XI. COMMENTS AND RESPONSES

This document contains public comments received on the Draft Environmental Impact Report (“Draft EIR” or “DEIR”) prepared for the proposed Balboa Park Station Area Plan and responses to those comments. Also included in this document are staff-initiated text changes.

FIGURE C&R 1 (Revised DEIR Figure 6)
Proposed Roadway Configuration and Circulation

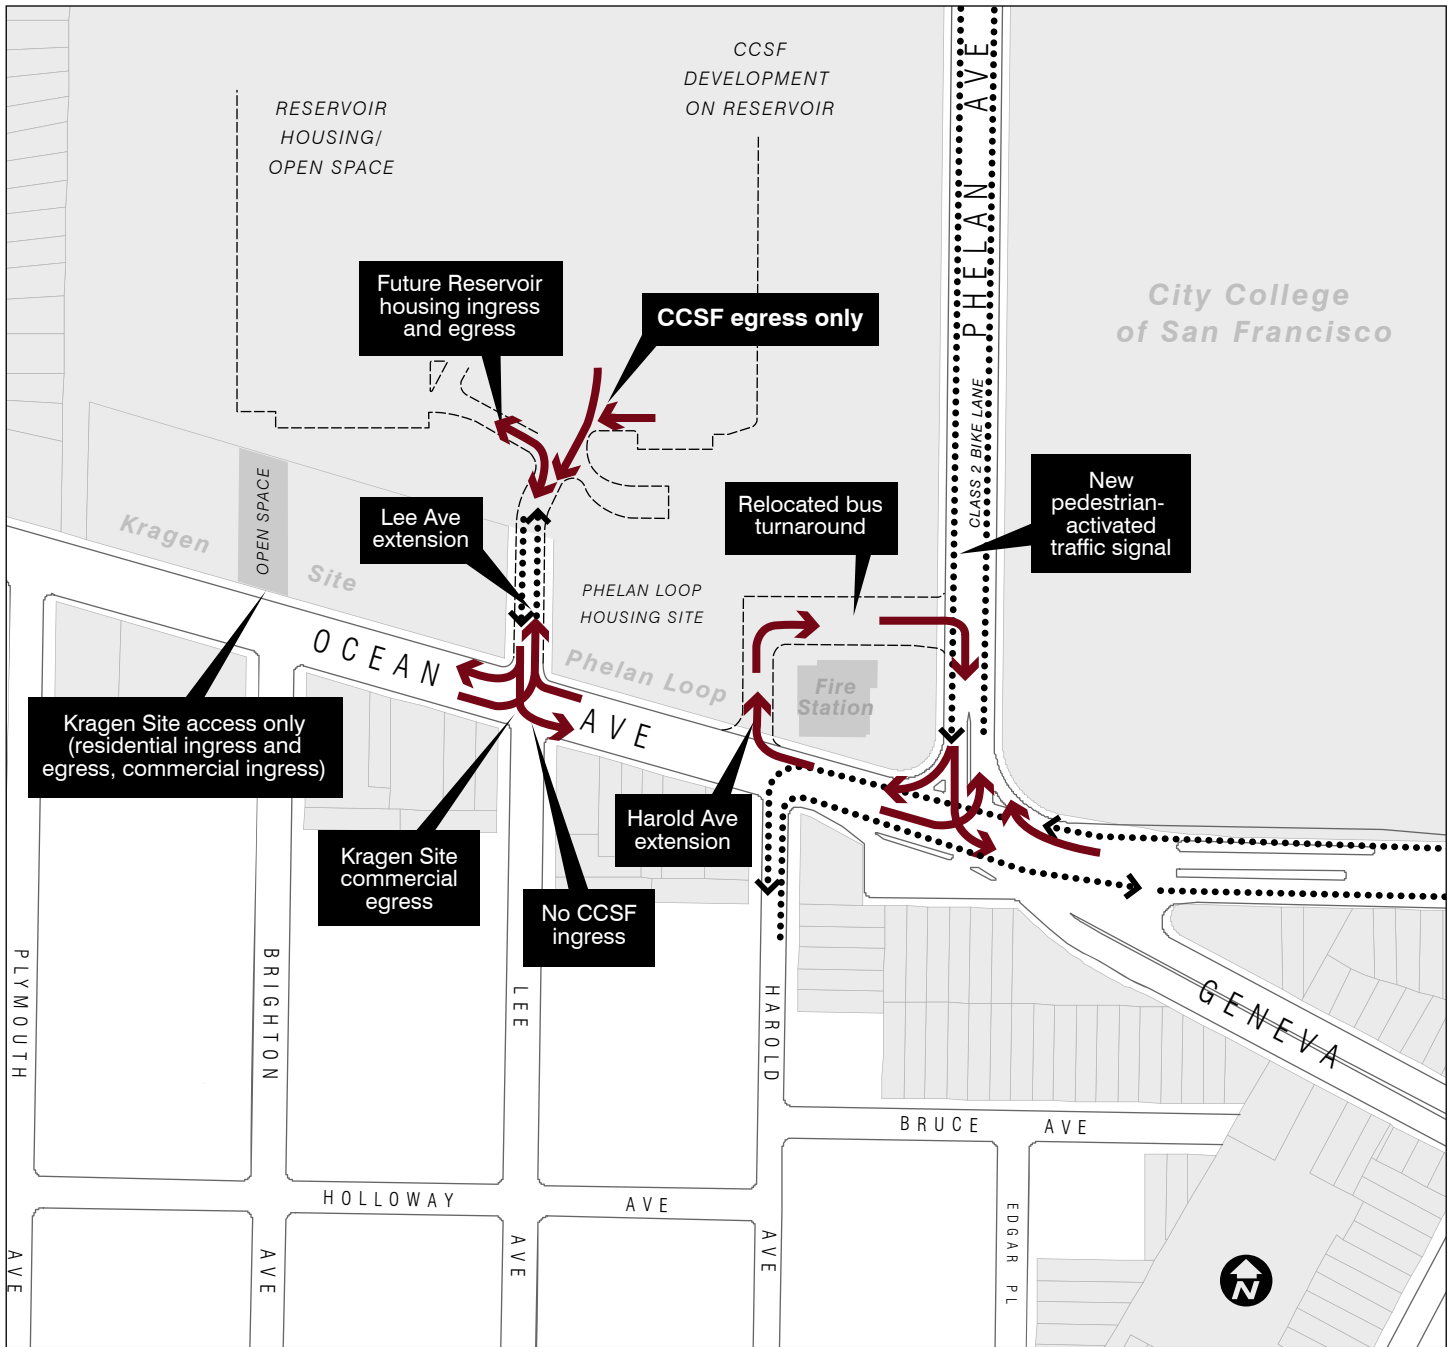
Page 195-207, Phelan Loop Development Sites and Kragen Auto Parts Sites: These two sites are getting, to some degree, project level clearance. The project descriptions for these two projects need to be accompanied by graphics. There is no proposed condition graphics for the Phelan Loop operations for bus access and exit. There is a detailed description for garage access to the Kragen Auto Parts Sites, presumably based on some plans. It would be helpful to the reader/reviewer if these plans are presented as part of the EIR or in the Appendix. (*MTA. Letter, Comment No. 60*)

Figure 6: This figure is to represent the existing condition on how MUNI buses access the bus yard at the end of the bus lines 49 and 9. The figure is faded and not legible.

This figure does not illustrate the reduction in size of the terminal, or the proposed new circulation paths or layover location and capacity of buses within the new terminal very well. (page 87, Figure 6) (*MTA, Muni Service Planning. Letter, Comment No. 112*)

Why has an upstream signal on Phelan at the Reservoir driveway, or at the exit itself been excluded from this discussion? Such a control device (at a location described on page 85, illustrated in Figure 6 on page 86 or similar to the existing traffic control device described on page 188) could be designed to provide Muni coaches the gaps they need to exit the new terminal and a way to improve pedestrian safety.

Figure C&R 1 on p. C&R-21 (revised DEIR Figure 6) shows proposed circulation at the Phelan Loop and Kragen Auto Parts Sites.

Figures 1, 2, and 10 have been reproduced in this C&R as Attachment 3 to improve legibility in print format. Figure 6 has been revised as Figure C&R 1 on p. C&R-21 to provide a clearer depiction of the proposed circulation along Ocean Avenue and Phelan Avenue and the Phelan Loop bus turnaround.

DEIR Figure 6 has been revised as Figure C&R 1 on p. C&R-21 to provide a clearer depiction of the circulation at the Phelan Loop site as currently planned; however, at this time, design plans for the Phelan Loop site have not been finalized.

FIGURE C&R 2 (Revised DEIR Figure 5)
Proposed Transit Reconfiguration

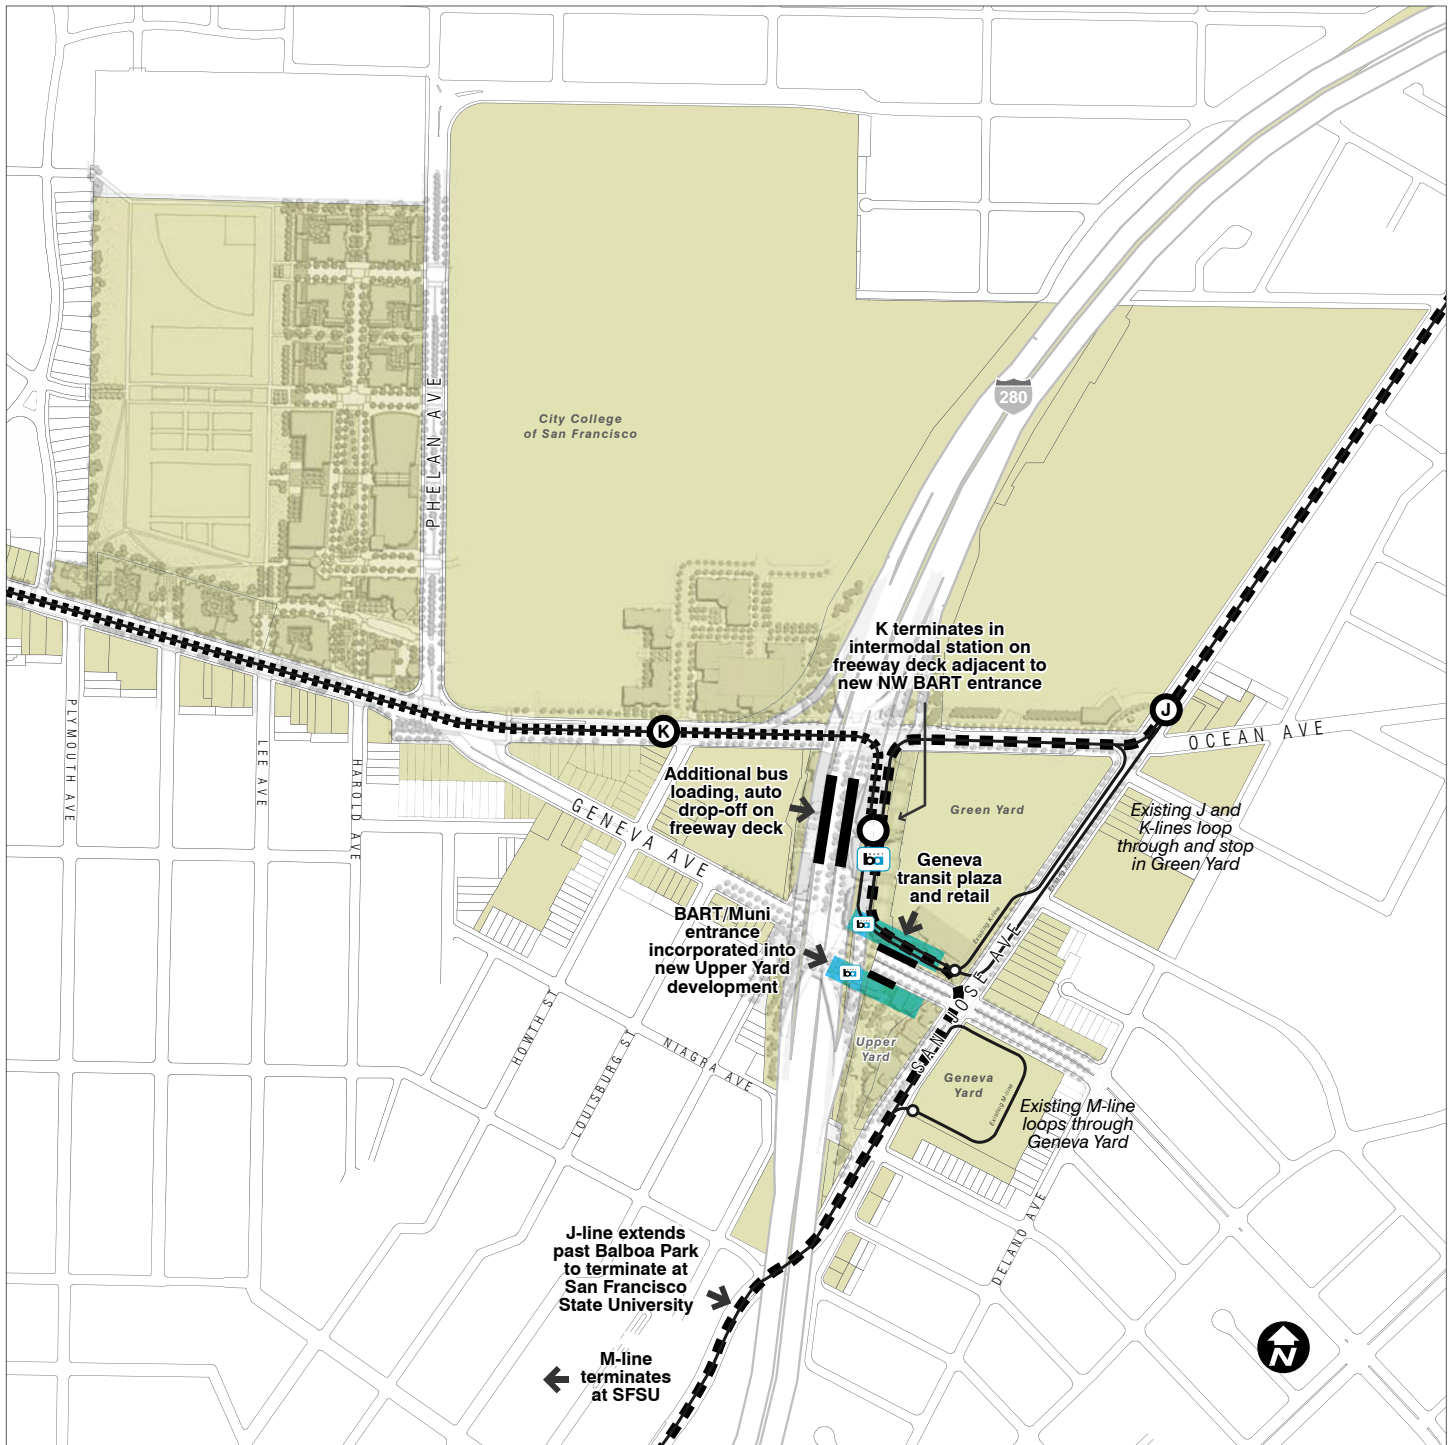
Without any direction arrow, street names or curb lines visible, it is difficult to understand what Figure 5, 'Proposed Transit Reconfiguration' is illustrating. (page 84) (*MTA, Muni Service Planning. Letter, Comment No. 111*)

- Page 84, Figure 5. The diagram for the proposed transportation improvements at the BART station is difficult to understand. It would be helpful to include a diagram that clearly illustrates the existing and proposed roadway and transit changes (see page 106 of the Draft Balboa Park Station Area Plan). (*BART. Letter, Comment No. 151*)

Page 84, Figure 5. Please clarify as the status of the proposal for the M-line to terminate below the Upper Yard at the BART mezzanine. There was prior discussion to drop this concept for further consideration. Past analysis showed that there was not enough space to accommodate the extension of the Muni line and joint development of the Upper Yard parcel. This issue was raised in our September 5, 2006 comment letter on the Balboa Park Station Area Plan Initial Study. (*BART. Letter, Comment No. 152*)

DEIR Figure 5 has been revised as Figure C&R 2 on p. C&R-22 to provide a clearer illustration of the existing conditions and proposed reconfiguration of Muni operations.

Figure 5 has been revised as Figure C&R 2 on p. C&R-22 to provide a clearer illustration of the existing transit conditions and proposed transit improvements. In addition, Figure 6 has been revised as Figure C&R 1 on p. C&R-21 to provide a clearer depiction of the proposed circulation at key Area Plan intersections.

The Municipal Transportation Agency is currently in the process of reevaluating Muni operations in an effort to improve transit service as part of the Transit Effectiveness Project (TEP). Based on the findings of the TEP, it has been recommended that Muni's M-Ocean View line terminate at San Francisco State University rather than at the Balboa Park BART Station Upper Yard, and that Muni's J-Church line be extended to meet the M-Ocean View line at San Francisco State University. Revised Figure 5 (Figure C&R 2 on p. C&R-22) reflects these changes. Further analysis, environmental review, and approvals would be necessary to implement these changes.

FIGURE 10: PROPOSED DEVELOPMENT AT PHELAN LOOP SITE AND KRAGEN AUTO PARTS SITE

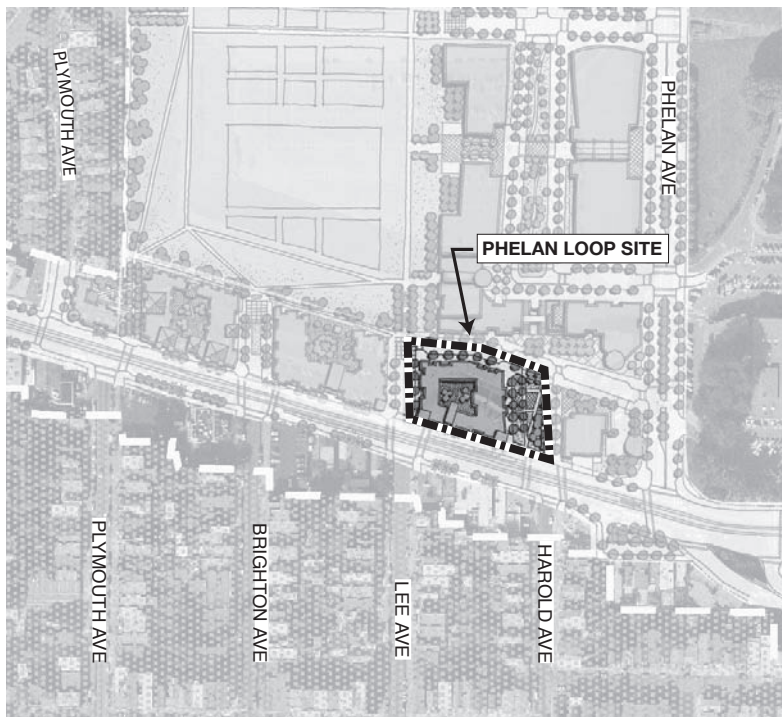
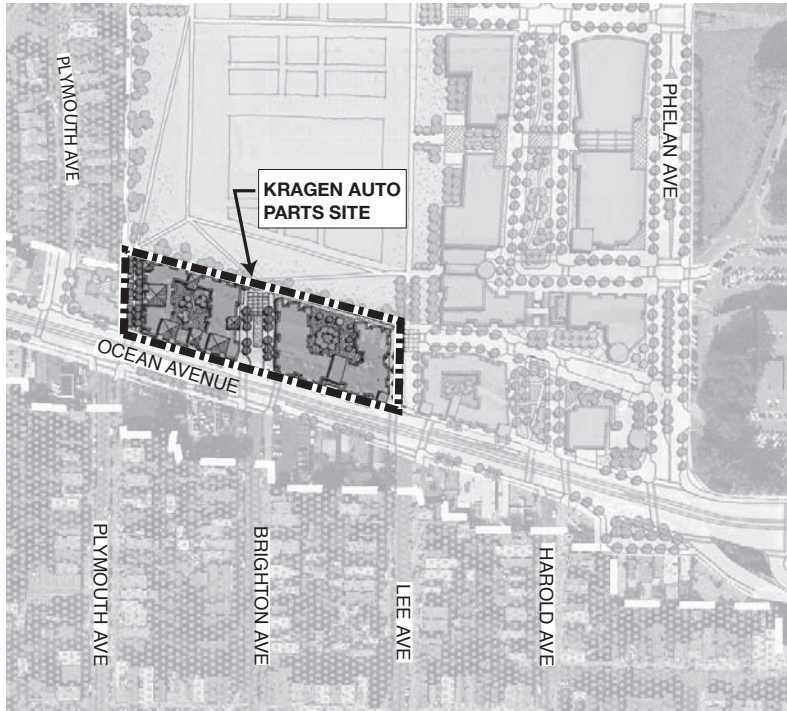
Figure 10: This figure is not legible. (MTA. Letter, Comment No. 31)

Figure 10: This figure is not legible.
